SUBJECT: USE OF UNSHIELDED TRANSFER CASKS IN SPENT FUEL
MOVEMENT

SUBJECT: EXEMPTION FROM 10 CFR 72.48, 10 CFR 72.212 AND 72.214 FOR DRY
SPENT FUEL STORAGE ACTIVITIES - FORT CALHOUN (TAC NO. L23984)

SAFETY EVALUATION REPORT
EXEMPTION FOR
OMAHA PUBLIC POWER DISTRICT
FORT CALHOUN STATION
INDEPENDENT SPENT FUEL STORAGE INSTALLATION
DOCKET NO. 72-54

Figure 1 - Supplemental Shielding in Decontamination Area

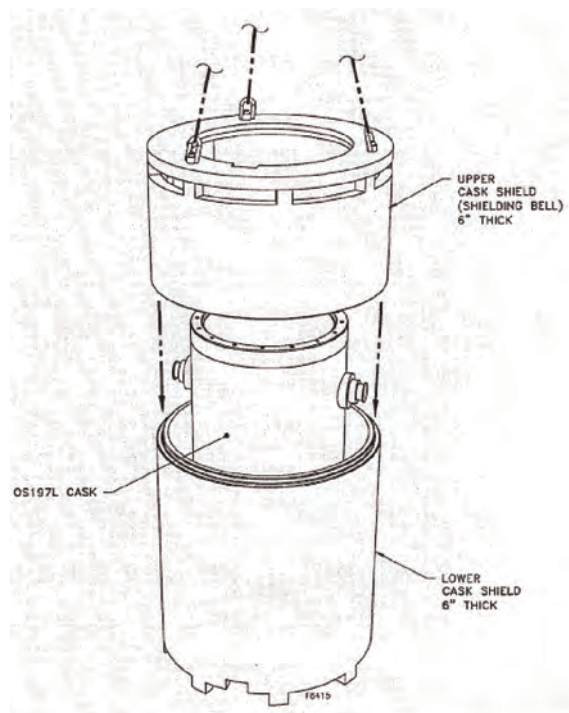
The supplemental shielding used in the decontamination area and on the transfer trailer is not part of the OS197L TC. Therefore, the staff does not agree with the applicant's assertion at the bottom of page 14 of Attachment 1 to the exemption request: "The radial shielding of the OS197L TC, including the decon area sleeve/bell, is documented in FCN 321, Rev. 1 [Attachment 1 of OPPD's exemption request], showing that the OS197L TC system

configuration has increased shielding.” In fact, the OS197L TC has significantly decreased shielding as compared to the OS197 TC.

In general, due to the potential for high dose rates in the vicinity of the TC during off-normal operations (if that condition were to occur when the TC was not within either of the supplemental shields), the staff concludes that the OS197L TC is not an optimum solution from a shielding and dose perspective. However, the staff recognizes the constraints placed upon the applicant and agrees that with the revised TS, the planned use of remote operations when the TC is outside of the supplemental shielding, and adherence to the radiation protection provisions included in the operating procedures in section M.8.1 of the FSAR the applicant is meeting the ALARA objective of TS 1.2.11.

Figure 2 - Supplemental Shielding on Transfer Trailer

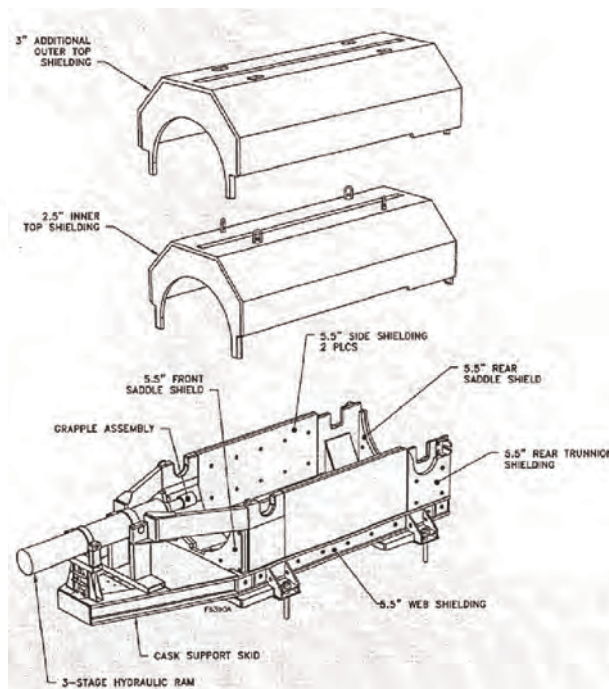
OPPD maintains that the 80-inch unrestricted drop analysis provided in the updated FSAR bounds accidents involving the transfer trailer shielding. The following two scenarios involving the transfer trailer shielding were addressed in the RAI and in OPPD's RAI response: 1) dropping of the 3-inch thick trailer outer top shield on the transfer cask, and 2) the impact the additional transfer trailer shielding would have on the 80-inch unrestricted drop analysis discussed in the updated FSAR.

failure-proof crane, dropping of the 2.5-inch thick trailer shielding does not have to be postulated. However, the 3-inch thick outer trailer top shield is placed using a non-single failure proof crane outside of the auxiliary building. OPPD states that the lift height of the 3-inch thick shielding will be administratively limited by procedure. In the response to RAI-4, OPPD evaluates the dropping of the 3-inch thick outer top shield and concludes that if it did drop it would contact the 2.5-inch thick inner top shielding and the load would be transferred directly to the skid/trailer, and then into the four 75-ton trailer jacks. OPPD maintains that the TC would not be affected by such a drop and the dropping of the 3-inch thick shielding is bounded by the updated FSAR evaluation of an 80-inch unrestricted drop of the TC. The staff agrees that the 80-inch drop analysis bounds the dropping of the 3-inch thick trailer outer top shield and therefore, dropping of the 3-inch thick shielding does not create the possibility of a new accident that requires prior NRC approval.

Regarding the impact that the transfer trailer shielding would have on the 80-inch unrestricted drop analysis, OPPD committed to adding a discussion through a FCS specific 72.212 evaluation prior to fuel handling. This discussion would be added to section W.11.1.3 of the updated FSAR and provides reasons for why any inclusion of additional structures, such as the skid, trailer, or shielding will only reduce the drop distance and will provide additional energy absorption, thus reducing the DSC g-levels in the analyzed 80-inch unrestricted drop analysis. The staff agrees that it is appropriate to add this discussion to the updated FSAR and also agrees with the conclusion that the 80-inch unrestricted drop analysis bounds accidents involving the transfer trailer shielding. The staff concludes that the transfer trailer shielding, therefore, does not create the possibility of a new accident that requires prior NRC approval.
